▪ <u>Plant:</u>	▪ <u>Harris Nuclear Plant</u>	▪ <u>Submittal Date:</u>	▪ <u>10/26/06</u>
▪	▪	▪	▪
▪ <u>Submitter Contact:</u>	▪ <u>Elizabeth Kleinsorg</u>	▪ <u>Phone</u>	▪ <u>704.651.5548</u>
▪	▪	▪	▪
▪	▪	▪ <u>Submitter Email:</u>	▪ <u>Insert email</u>

Section B.2.2.4 Recovery Actions

**Attachment to FAQ 06-0012 Revision 0**  
**Excerpt from NEI 04-02 Revision 1 with changes tracked**

**Figure B-4 Acceptable Manual Action in Fire Area Meeting 10 CFR 50, Appendix R, Section III.G.1 Separation Criteria**

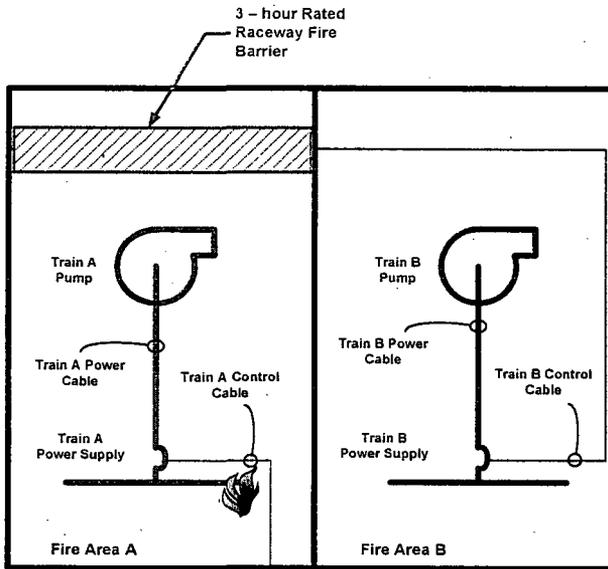
- Operation of fire affected equipment for fire areas that meet the separation requirements of Section III.G.1 of 10 CFR Part 50, Appendix R (or applicable sections of NUREG-0800). See Figure B-4

Fire Area A and B meet the separation criteria of 10 CFR 50 Appendix R Section III.G.1. A postulated fire in Fire Area A could result in the spurious starting of the Train A pump, which can be mitigated by a manual operator action to de-energize the Train A Power Supply to stop Pump A.
